NOVEMBER 18, 2011

MASTER DRAINAGE STUDY

SANTA MONICA PLACE
San Pedro and Derickson Avenue NE

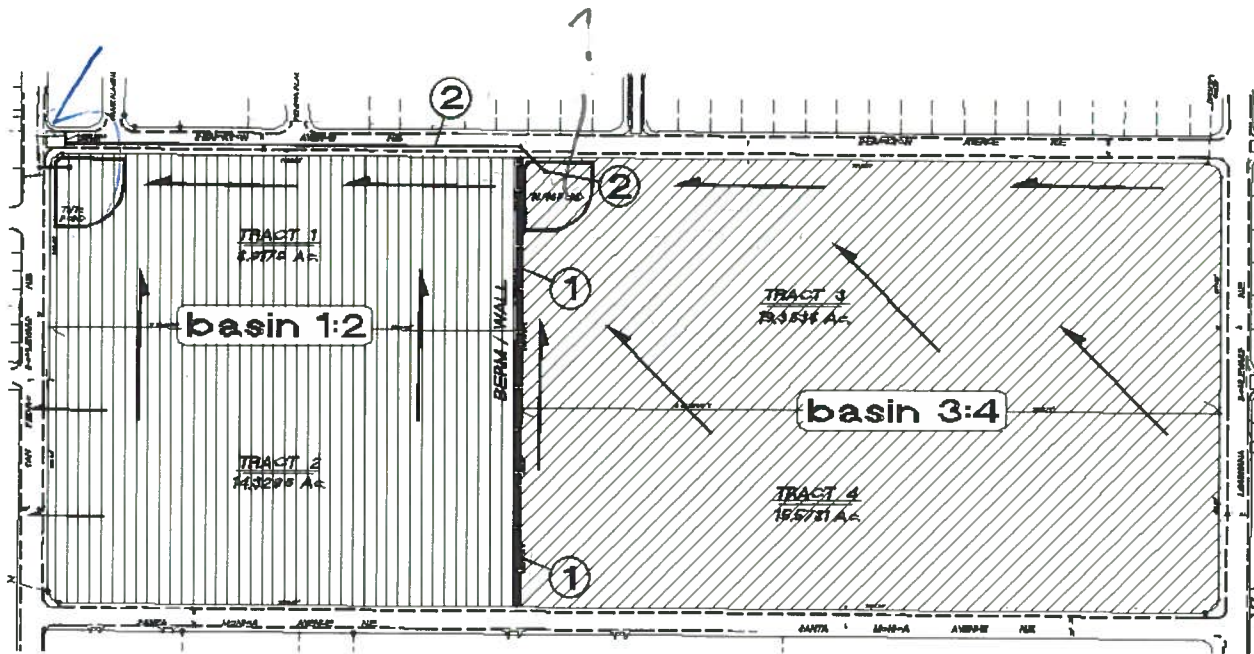
*if Tract 1/2 develop first, Hydrology could
(Sediment pond)
force developer to grade on adjacent property,
and storm drain built,
unless this site is graded as part of
PP approval, site to the west will have
to accept existing flows*

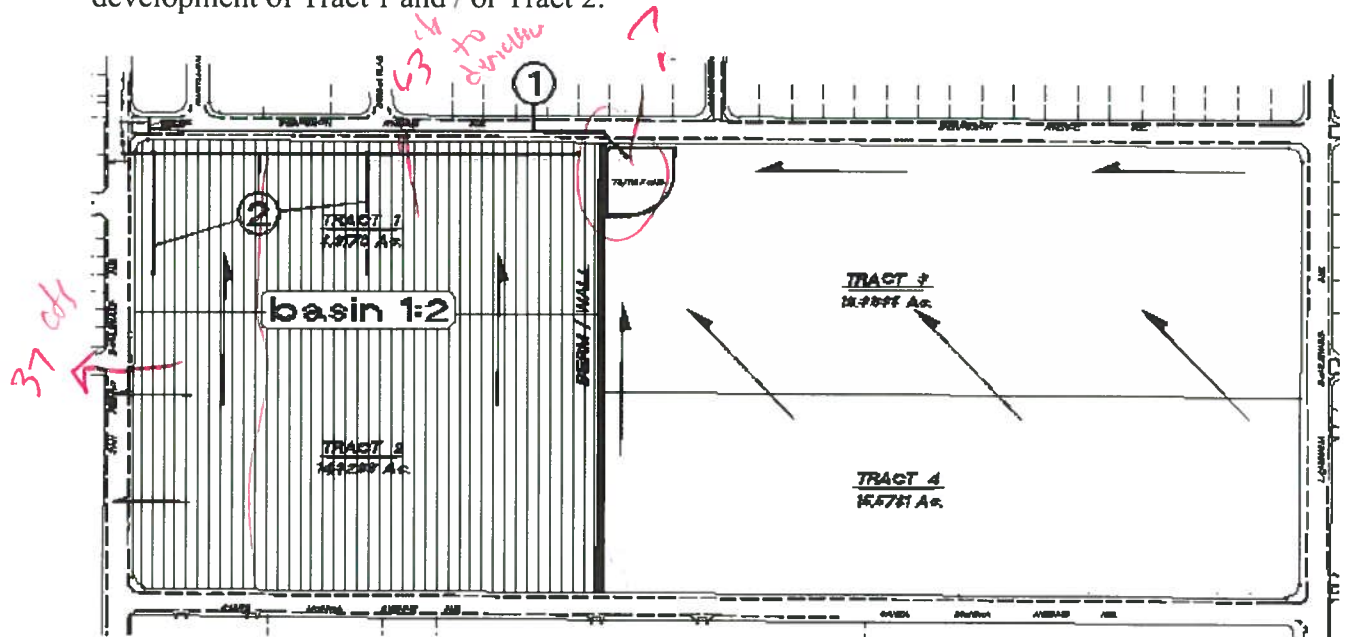
7. Undeveloped tracts shall be graded to drain to detention ponds / desiltation basins.

grade now
